**Marion County  
Board of County Commissioners**

**PLANNING & ZONING SECTION  
STAFF REPORT**

<b>P&amp;ZC Date: 10/30/2023</b>	<b>BCC Date: TBD</b>
<b>Case Number:</b>	231111ZP	
<b>CDP-AR:</b>	30579	
<b>Type of Case:</b>	<b>Rezoning</b> from General Agriculture (A-1), Agricultural Estate (A-3), Community Business (B-2) and Light Industrial (M-1) to Planned Unit Development (PUD)	
<b>Owner</b>	Multiple Owners, c/o Robert A. Bull Agent, Tillman & Associates Engineering, LLC	
<b>Applicant</b>	Tillman and Associates Engineering, LLC	
<b>Street Address</b>	Address not assigned; Jumbolair	
<b>Parcel Number</b>	14106-000-00, 14591-000-00, 14105-000-00, 14601-001-00, 14202-000-00, 14600-001-00, 14560-000-00, 14567-001-00, 14567-000-00, 14571-000-00, 14561-000-00, 14569-001-00, 14569-000-00, 14574-000-00, 14568-000-00, 14575-000-00, 14592-006-00, 14601-000-00, 14605-000-00, 14583-002-00, 14583-001-00, 14583-003-00, 14730-000-00	
<b>Property Size</b>	±449.66	
<b>Future Land Use</b>	Rural Land (RL), Low Residential (LR), Medium Residential (MR), Commercial (COM)

**Figure 2  
Conceptual Plan**

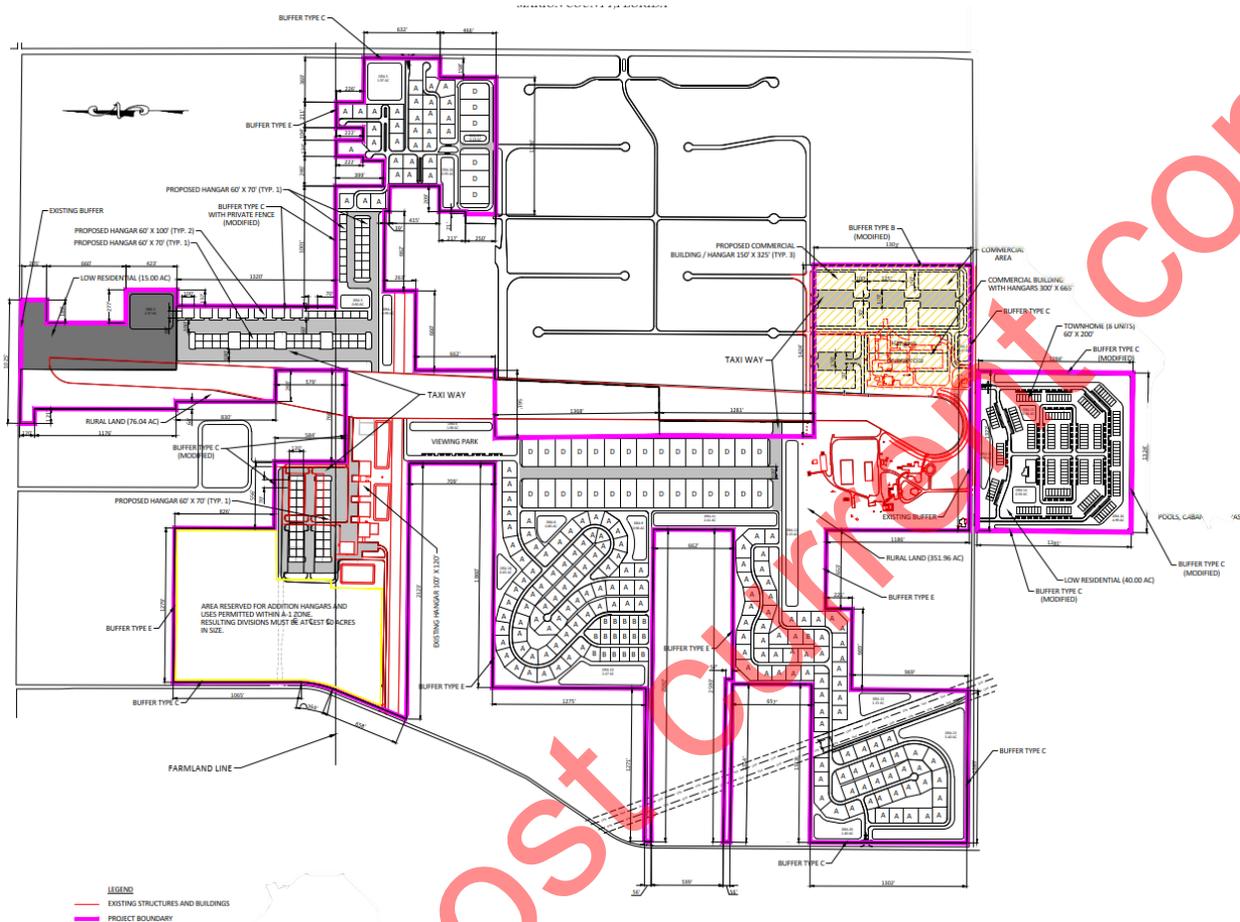
**Analysis:** Buffer details are proposed within the application (see Attachment A). Staff finds that the PUD is proposing a series of modified buffers that are less than the standards required in the Marion County Land Development Code. Other areas are proposing no buffers. The surrounding residential uses have much larger lots than the lot sizes proposed in the PUD. To help with compatibility, staff recommends the following conditions be imposed:

- Buffers shall be provided as shown on the submitted conceptual plan, and as noted below.
  - Lime Green line: Leave existing trees in place and install a 6' opaque vinyl fence on the interior side of the line.

- Dark Blue line: Modified Type E buffer with a 6' opaque vinyl fence on the interior of the buffer and shall consist of a five-foot wide landscape strip without a buffer wall. The buffer shall contain at least four shade trees for every 100 lineal feet or fractional part thereof. Shrubs shall be planted in a double-staggered row and be capable of reaching a maintained height of six feet within three years. Groundcovers and/or turfgrass shall not be used in this buffer.

- Yellow line: Modified Type C Buffer that is 10' wide as shown in the application but with a 6' opaque vinyl fence.
  - Dark Red line: Modified Type B buffer as shown on the conceptual plan. The opaque fence shall be vinyl and on the interior of the buffer.

- A Type C Buffer shall be included along all right-of-ways.
- Any buffer not addressed with these conditions shall meet the standards of the Marion County Land Development Code.
